Product Change Notification

PCN #: 20190905-1

Modification of the base for AZ733 and AZ733W series.

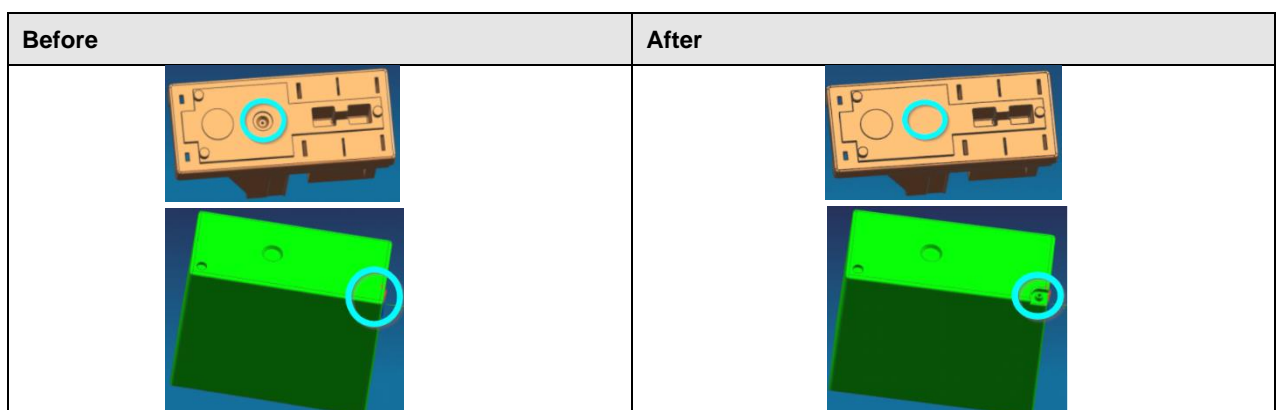
Transposition of the exhaust hole from the base to the upper part of the relay.

Switching from epoxy- to hot sealing of the exhaust hole.
